# SERVICE BULLETIN

No. 663

Piper Aircraft Corporation

Subject: Fuel Line/Electrical Harness Inspection

LEFT ENGINE NACELLE SHOWN  
RIGHT ENGINE NACELLE OPPOSITE

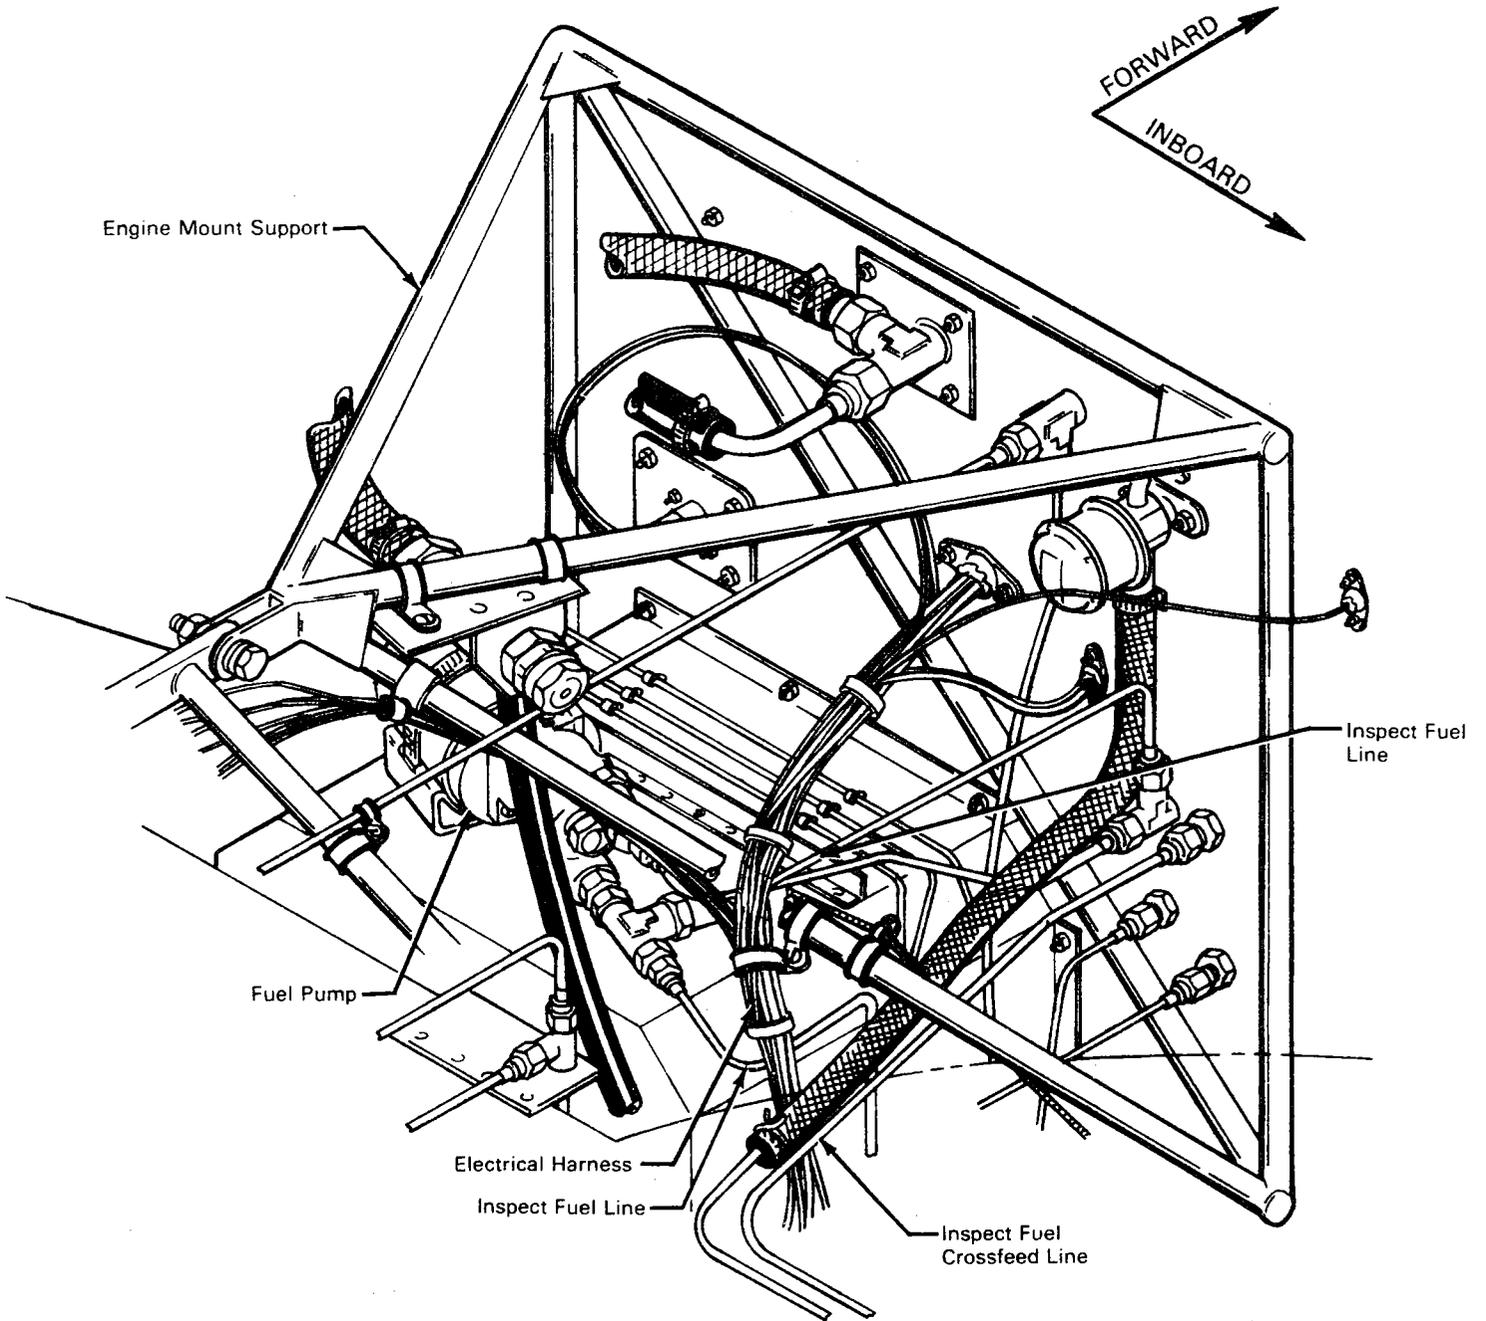
1. Remove access cover assemblies to gain access to the area aft of the firewall.
2. Refer to attached sketch. Inspect to insure electrical wiring harness is not in contact with the fuel line in the area of the electrical fuel pump or the fuel crossfeed line.
3. If harness is in contact with a fuel line, reposition electrical harness and secure with ty-raps or clamps.
4. Inspect fuel lines for evidence of chafing. If fuel line is not in airworthy condition, replace it before further flight. Refer to Parts Catalog for appropriate replacement part.
5. Reinstall access cover assemblies.
6. Make appropriate logbook entry of compliance with this Service Release.
